STATION HILL READING

AMENDMENTS TO RMA REF:
201537/REM PLOT E

JULY 2024

NMA 09

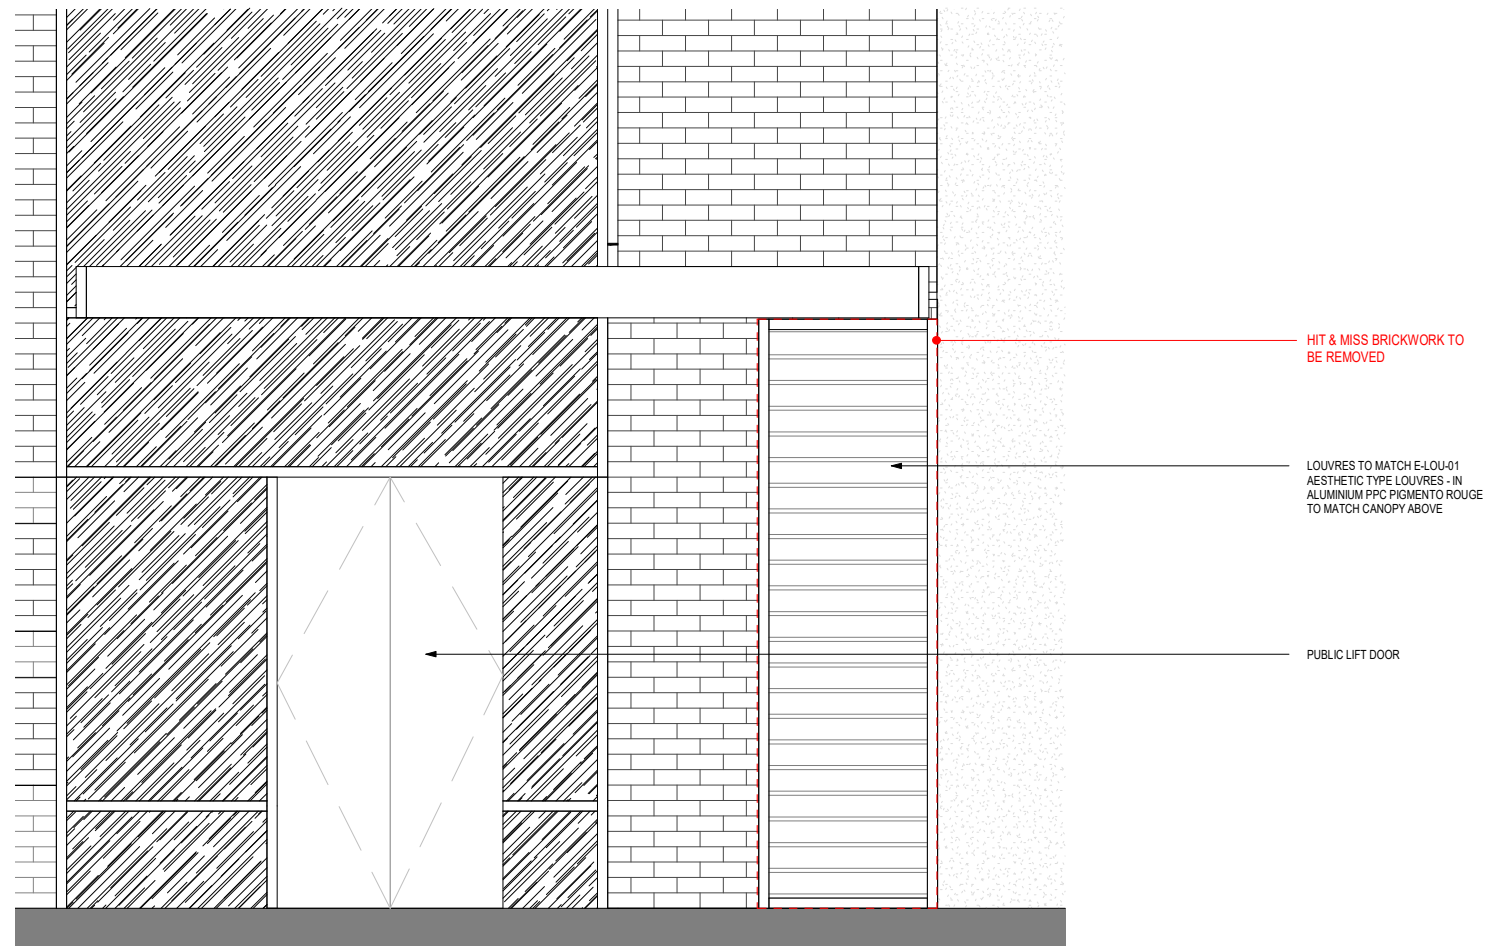
This NMA relates to a small section of facade on the northern edge of the scheme, along Garrard street. The section of facade relates to the Gas Intake room, at Lower Ground level, and is approximate 0.8m x 2.8m.

The proposal is to change the currently approved Hit & Miss brickwork section to a horizontal Z-Profile louvre system which is typical along this facade around the car park areas. This would be Aluminium and PPC to match the canopy adjacent in Pigmento Rouge.

The change comes due to concerns around the visibility through the current hit and miss brickwork, as well as addressing challenges related to littering within the openings of the brickwork, the horizontal louvres will address these issues whilst still allowing for the required free area to ventilate the space behind.

1 Block E - Lower Ground Floor Level
1:250

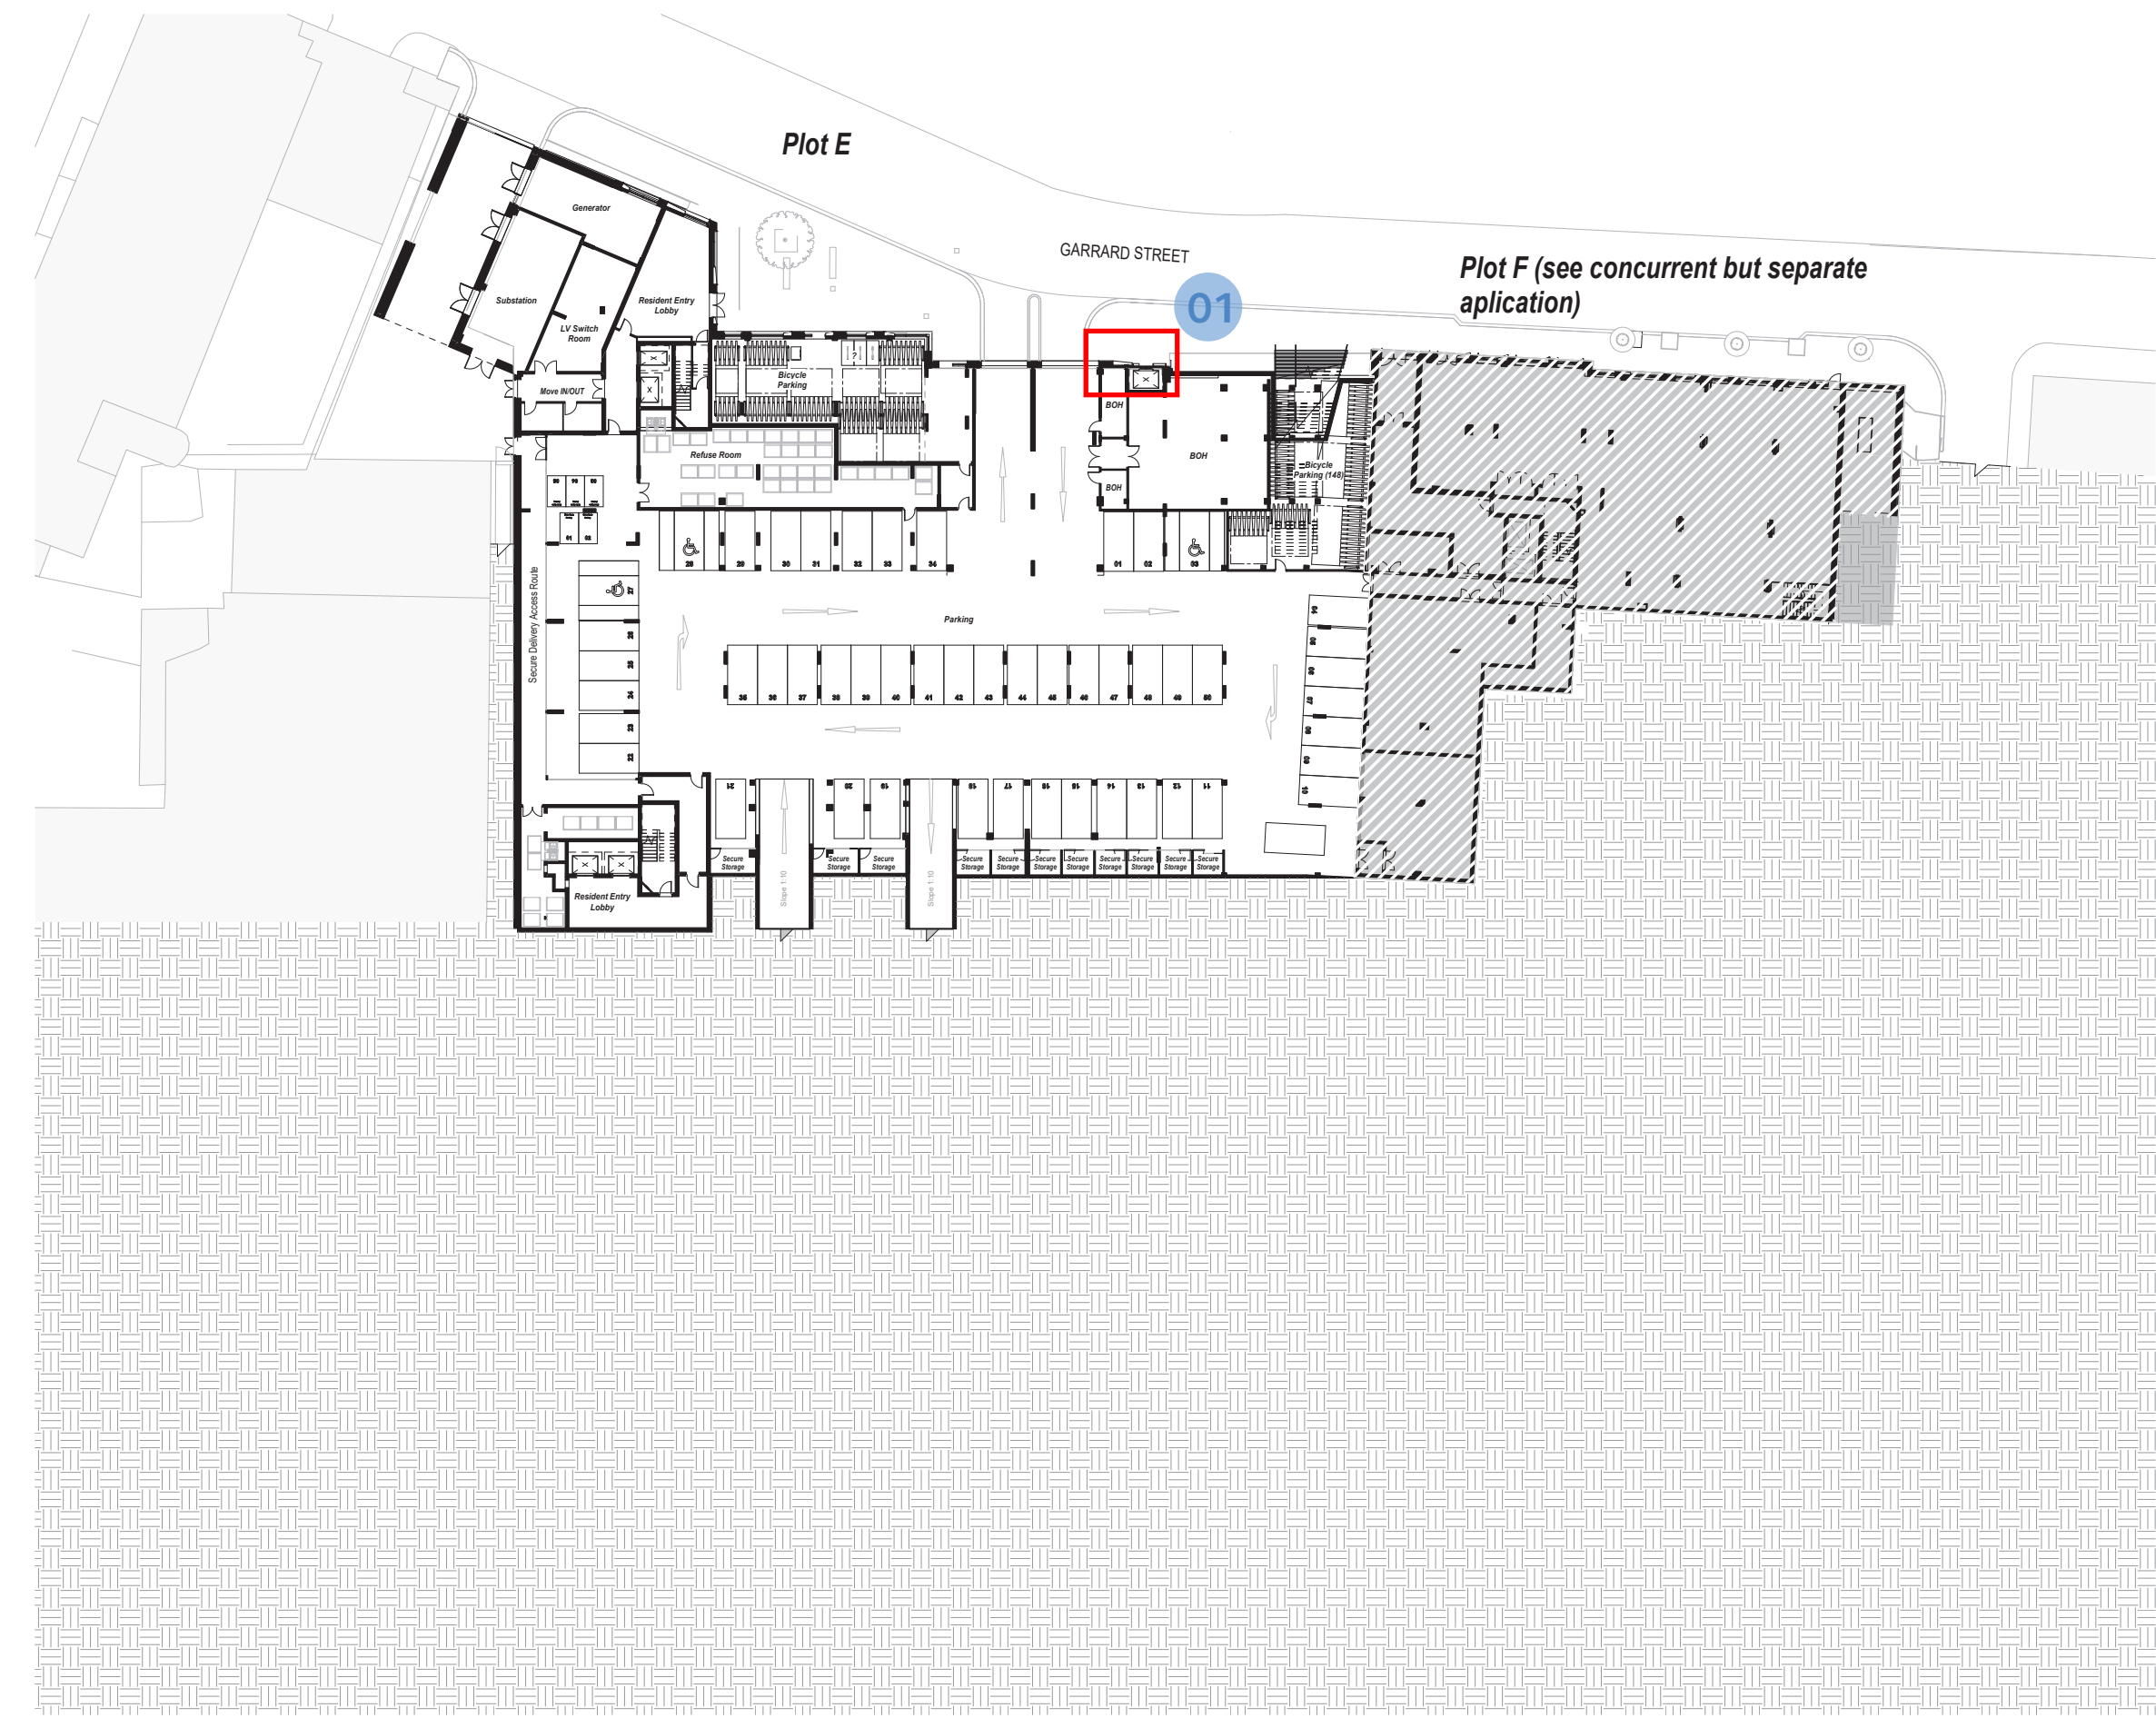
01
Horizontal Louvres in place of Hit & Miss brickwork to Gas Intake Room

1 Site - Garrard Street Elevation Plots F and E
1 : 250

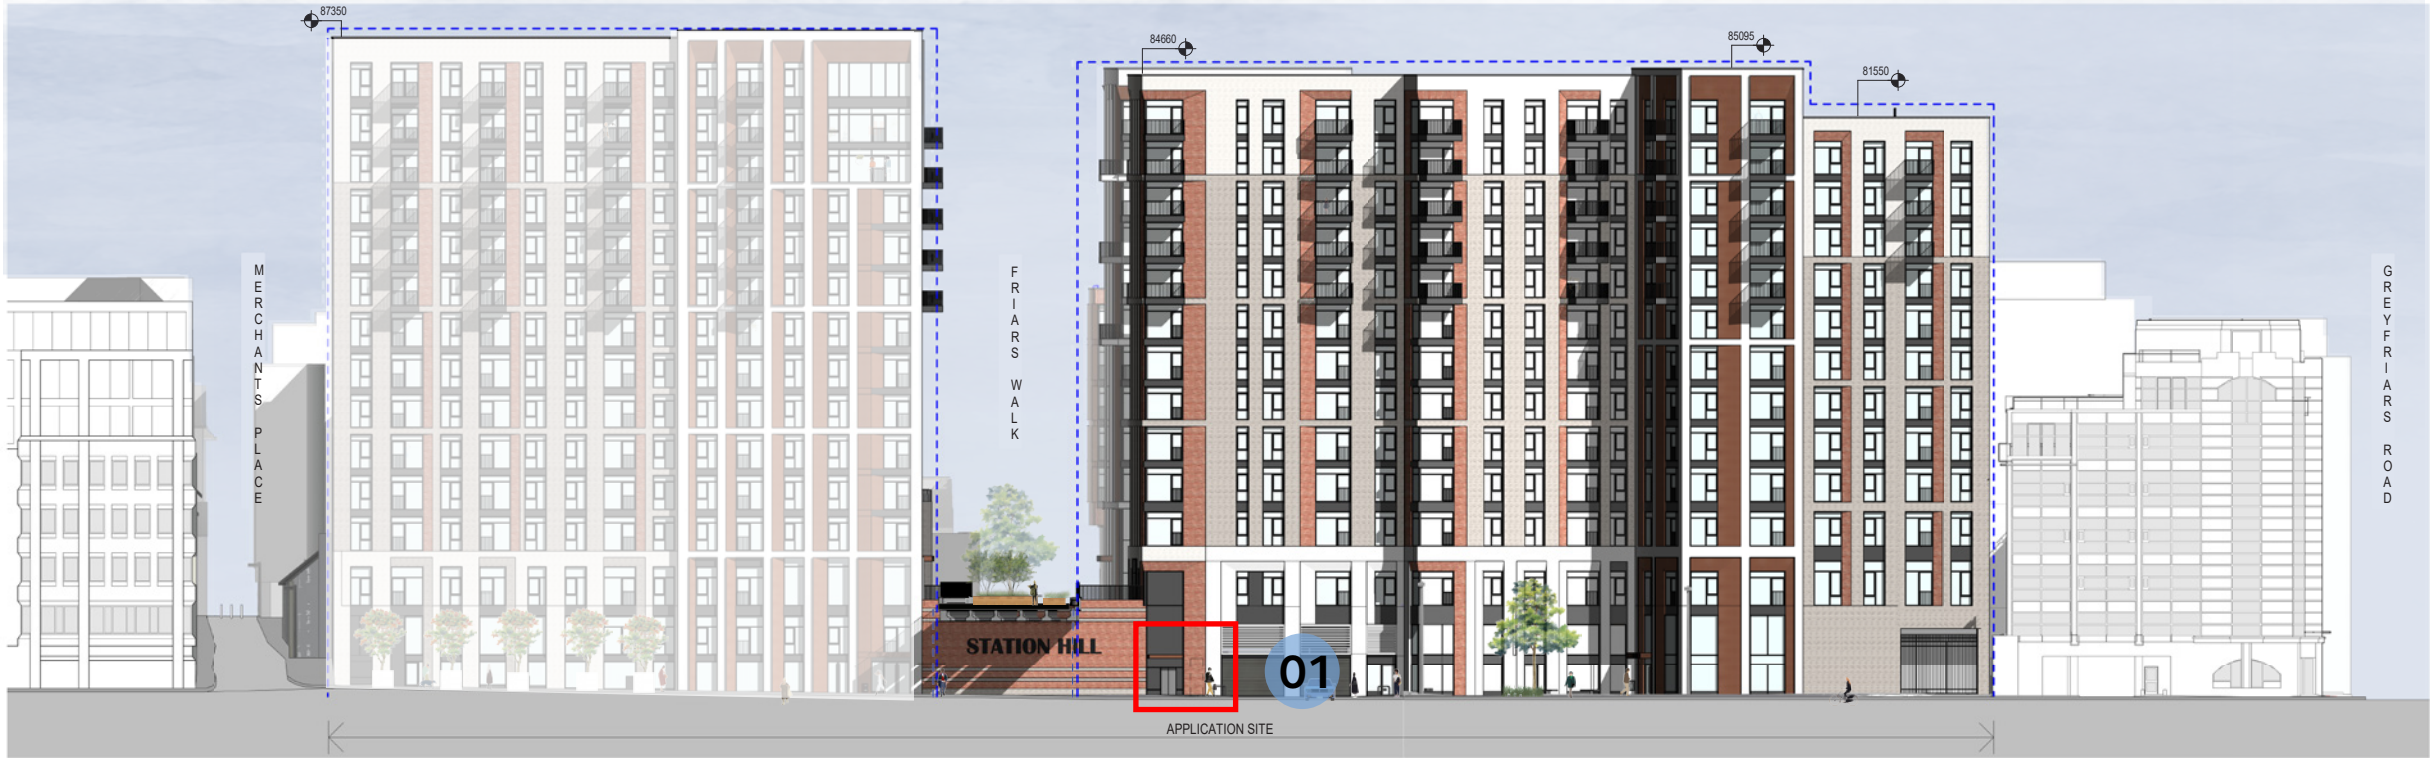
300(w)x2800(h)mm
